Seventy-fifth session Geneva, 27–31 May 2024 Item 7 of the provisional agenda UN Regulation No. 16 (Safety-belts)

Proposal for the [11] Series of Amendments of UN Regulation No. [16] (Safety-belts)

Submitted by the experts of the Ad Hoc Group on Safety-belts Reminder*

Arrangements of the safety-belt approval marks (see paragraph 5.3.5. of this Regulation)

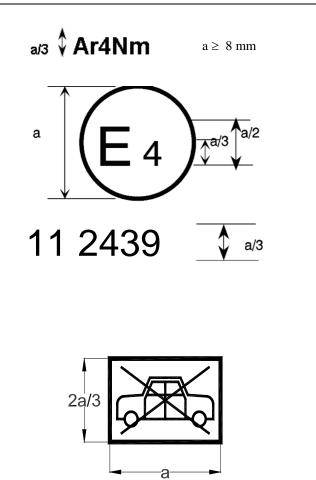
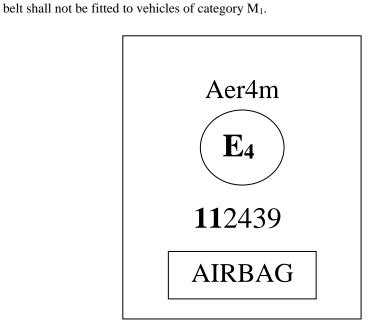
The belt ... the 06, 07, 08, 09, 10 or 11 series of amendments at the time of approval.

The belt ... 06, 07, 08, 09 or 11 series of amendments at the time of approval.

The belt bearing ... the 06, 07, 08, 09, 10 or 11 series of amendments at the time of approval.

The belt ... the 06, 07, 08, 09, 10 or 11 series of amendments at the time of approval.

The belt ... the 06, 07, 08, 09, 10 or **11** series of amendments at the time of approval. This

The \dots 06, 07, 08, 09, 10 or **11** series of amendments at the time of the approval. This safety-belt has to be fitted to a vehicle equipped with an airbag in the given seating position."
